SUBJECT: CORE RELOAD (TAC NO. 64442)

RE: PEACH BOTTOM ATOMIC POWER STATION, UNIT NO. 2

AMENDMENT TO FACILITY OPERATING LICENSE

Amendment No. 123
License No. DPR-44

FIGURE 1.1-1

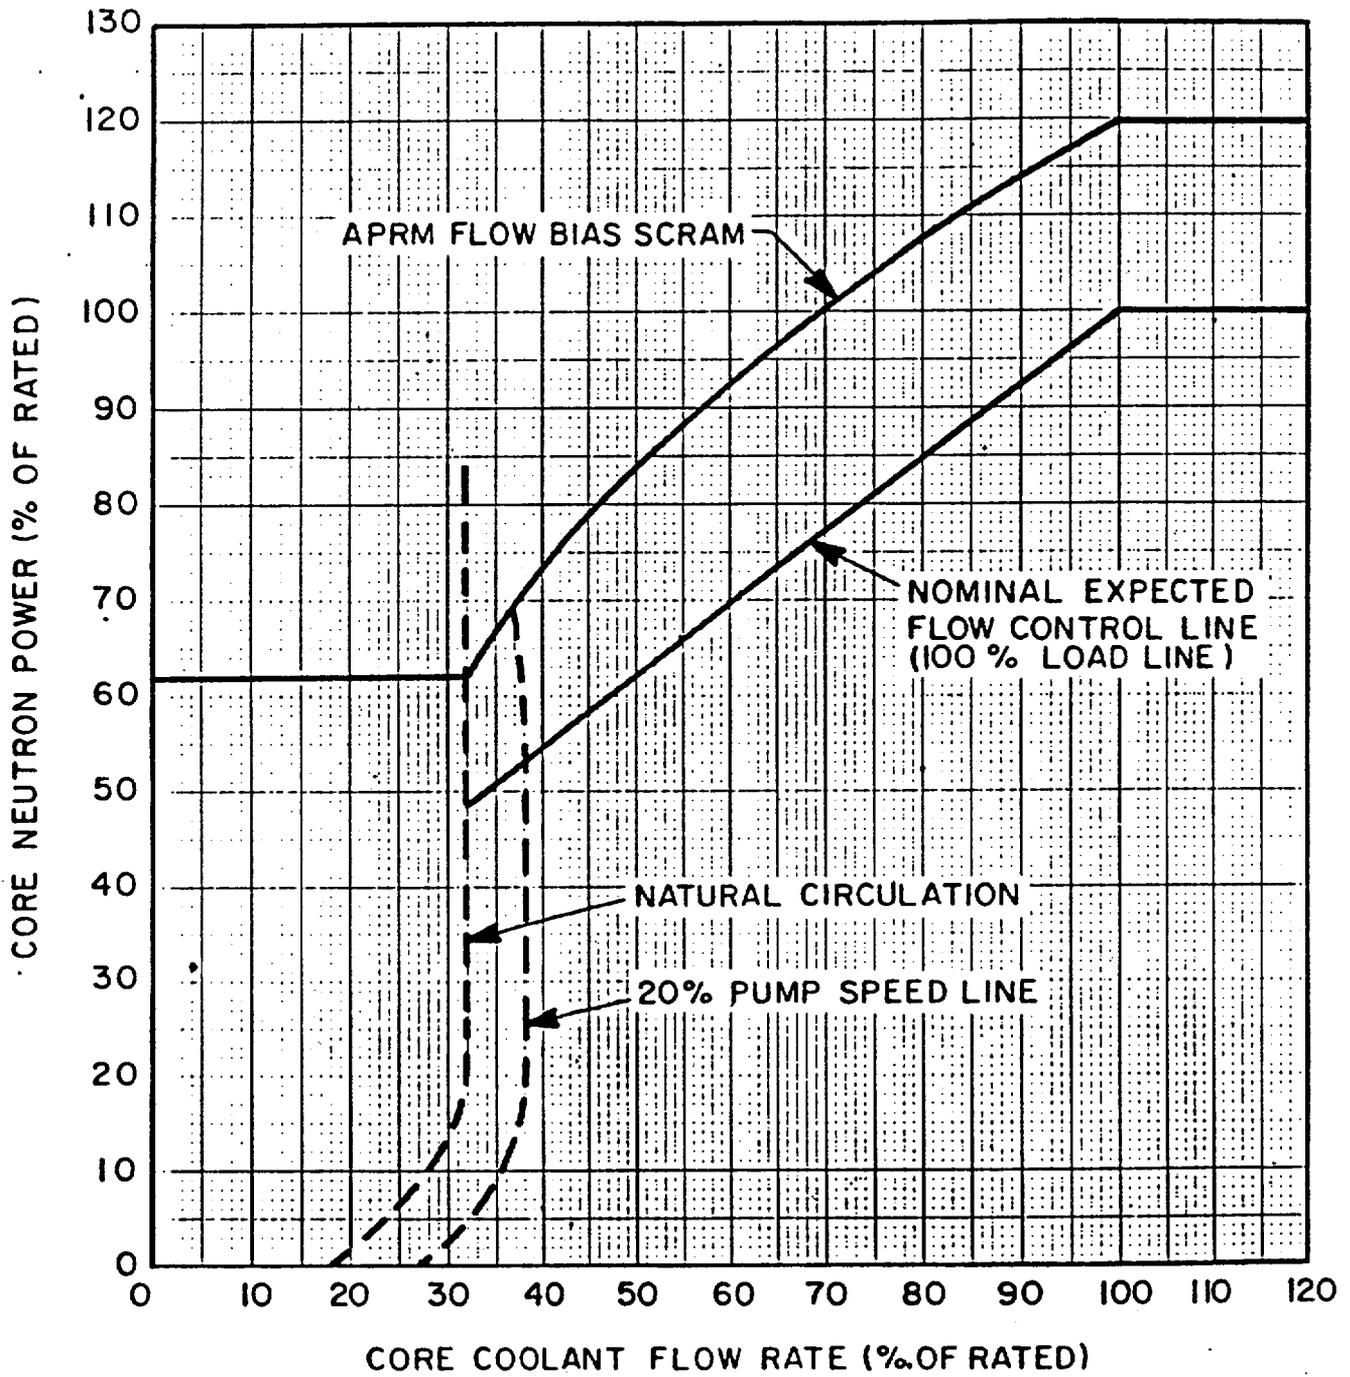
- (a) The new ELLLA APRM scram and rod block flow dependent setpoints. The changes are to TS 2.1.A.1 and 2.1.B, Figure 1.1-1, Tables 3.1.1 and 3.2.C and are acceptable.
- (b) The new MCPR limits for Cycle 8 and for ICF operation. The changes are to TS 3/4.5.K, Tables 3.5.K.2 and .3 and Figures 3.5.K.1 to 3 and 3.5.K.2-1 to 3, and are acceptable.
- (c) The 14.4 KW/ft LHGR limit for the new (GE 8x8EB and LTA) fuel. The changes are to TS 2.1.A and B, 3.5.J and Tables 3.1.1 and 3.2.C, and are acceptable.
- (d) MAPLHGR limits for the new fuel. The changes, which were revised in Reference 7 from those in the original submittal, are to TS 3.5.I and Figures 3.5.1.M to O and are acceptable.
